Responses to Late Comment Letters Received on the Draft Subsequent Environmental Impact Report

CASE NUMBER(s): Specific Plan Amendment (PEN23-0109), General Plan Amendment (PEN23-0127), Change of Zone (PEN24-0041), Tentative Tract Map No. 38850 (PEN23-0118), and Development Agreement (PEN23-0119)

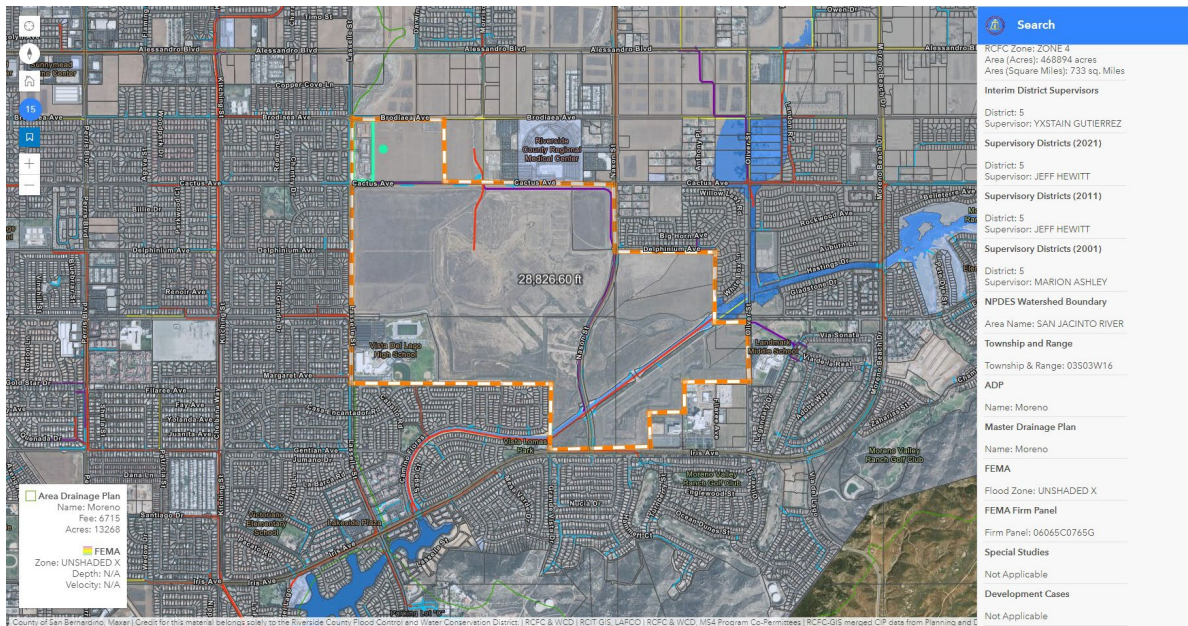
We received the attached notice (1st attachment) for the City of Moreno Valley Planning Commission hearing. When I reviewed the COAs for the Tract Map 38850 (2nd attachment) I am not seeing how our comments in the previous District response letter (3rd attachment) are being addressed.

Legend for screen capture below:
Purple lines are pending approval – about to be RCFC maintenance.
Red lines are RCFC existing facilities.
Yellow are proposed RCFC Master Drainage Plan facilities.
Light blue are city storm drain/drainage facilities.

- A8-1.** This comment letter stated that the reviewer did not see how previous comments made by the RCFC were addressed. However, another letter was sent by this commenter to follow-up on this statement. Please see Comment Letter A9 and response below.

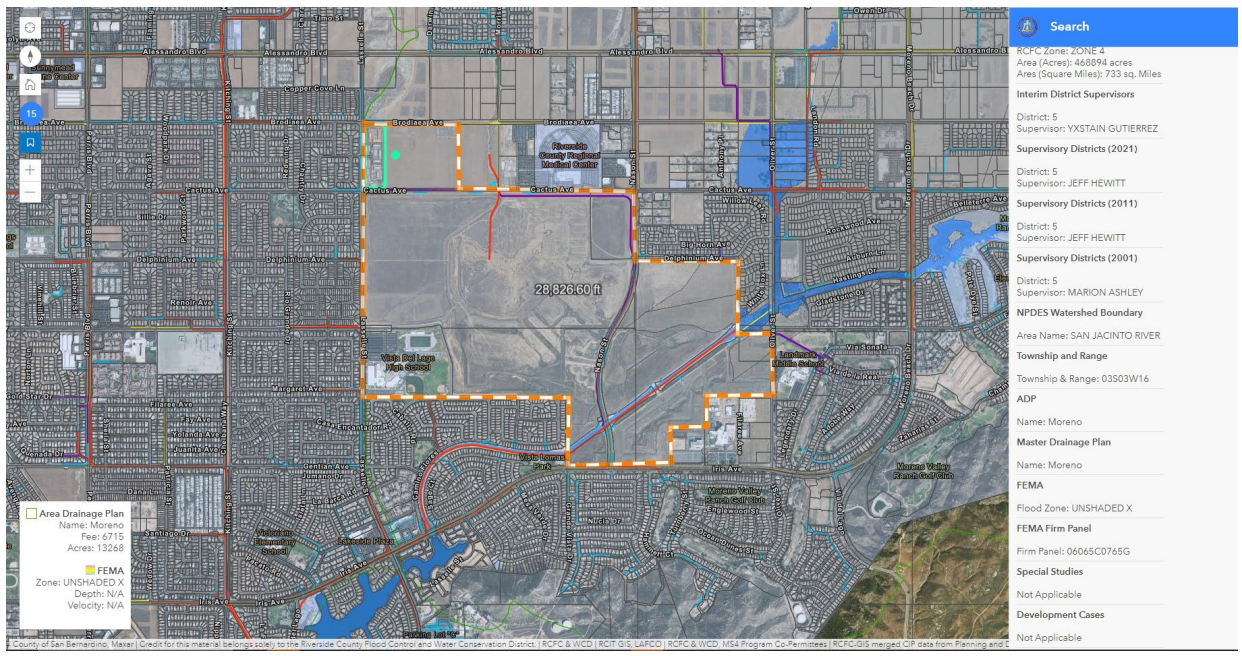
We received the attached notice (1st attachment) for the City of Moreno Valley Planning Commission hearing. When I reviewed the COAs for the Tract Map 38850 (2nd attachment) I am not seeing how our comments in the previous District response letter (3rd attachment) are being addressed.

Legend for screen capture below:
Purple lines are pending approval – about to be RCFC maintenance.
Red lines are RCFC existing facilities.
Yellow are proposed RCFC Master Drainage Plan facilities.
Light blue are city storm drain/drainage facilities.

- A9 -1.** This comment is a follow-up to Comment Letter A8. The commenter clarified that since no construction is proposed with the submittal/approval the RCFC has no further comments. The City thanks the commenter for this comment. The comment does not identify any specific issue with respect to the adequacy of the Draft SEIR; therefore, no further response is required.
